Compatibility Advisory

Title	Compatibility Advisory for ESP32-C3 Chip Revision v1.1
Issue date	2025/04/14
Advisory Number	AR2024-009
Serial Number	ΝΑ
Version	V1.1

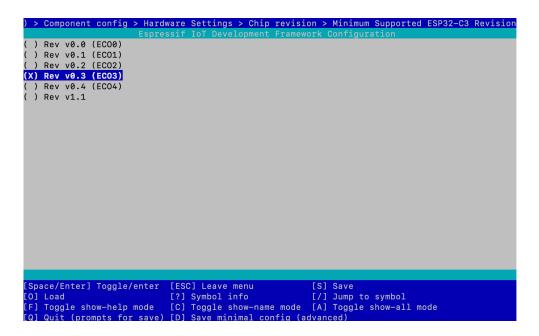
Set "Minimum Supported ESP32-C3 Revision" in "menuconfig": When running the project configuration utility "menuconfig" of ESP-IDF, set "Minimum Supported ESP32-C3 Revision" (> Component config > Hardware Settings > Chip revision) as "Rev v1.1". The default value is "Rev v0.3".
